PCN# : P4B9AAB
Issue Date : Feb. 12, 2015

DESIGN/PROCESS CHANGE NOTIFICATION

Single manufacturing source location at Suzhou
Original mark (put FSB50450S as example)

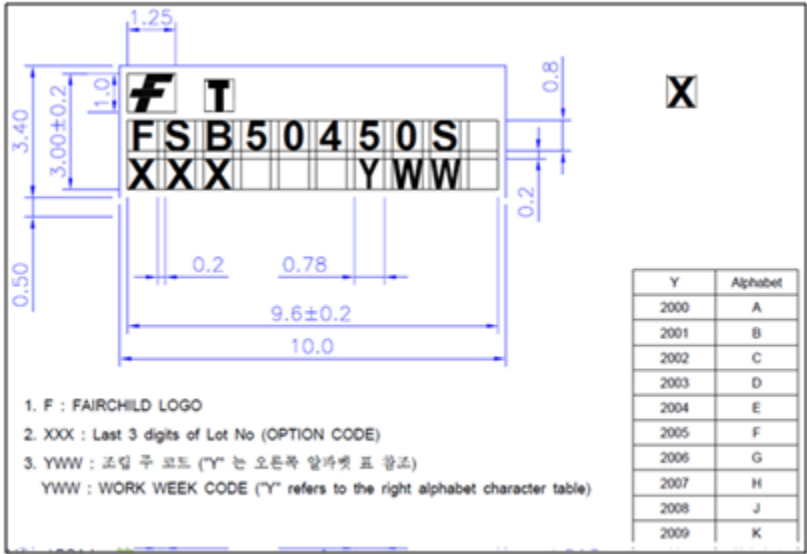
Description of Change (From) :

Description of Change (To) :
Additional manufacturing source location at Taiwan
Mark change to below with plant code 'T' after Fairchild logo 'F'. 'T' size and font same as below device name.
